### **REMARKS/ARGUMENTS**

In the office action mailed August 18, 2003, claims 1-6 are pending. Claims 1, 3, and 5 are rejected and claims 2, 4 and 6 are objected to. The arguments below follow the order set forth in the office action.

FIG-4

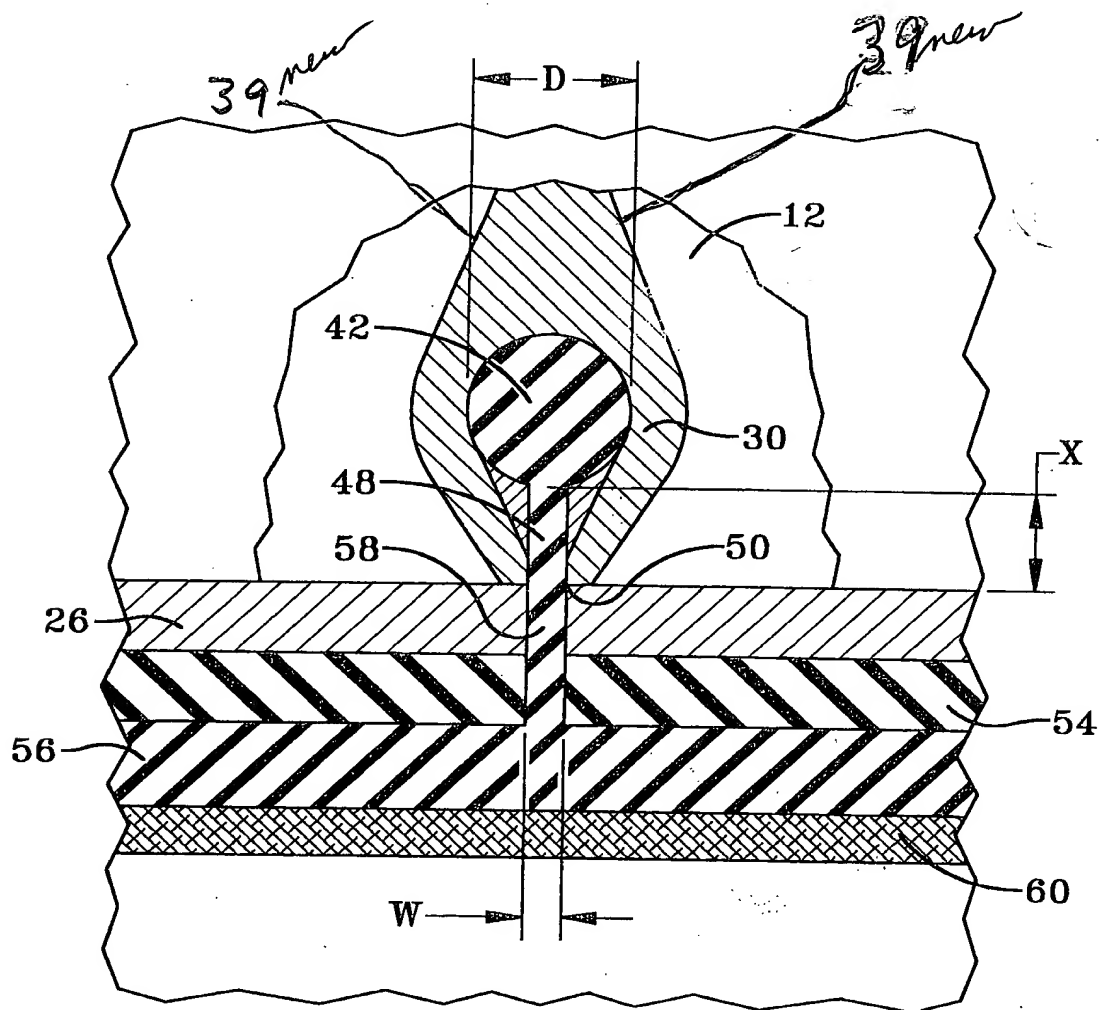
The drawings were objected to because the tapered walls of claim 4 to divert the flow of the outer tread around the chimney block of claim 6 must be shown. The tapered walls are shown in Figs. 1 and 4 and described on page 5, lines 6 – 8, where the “flow splitting tapered upstream edge 38 of tapered walls 39” is set forth. Figs 1, 2 and 4 have been amended by changing the lead line to numeral “38” to identify the tapered upstream edge and numeral “39” added to identify the “tapered walls.” Showing the tapered upstream edge 38 clearly identifies the “tapered walls 39” which create the edge. Reconsideration of this objection is respectfully requested.

In Fig. 4, numeral 39 has been added. Marked up copies of the drawings showing these changes in red are also enclosed. A Request for Drawing Amendment is being filed simultaneously herewith.
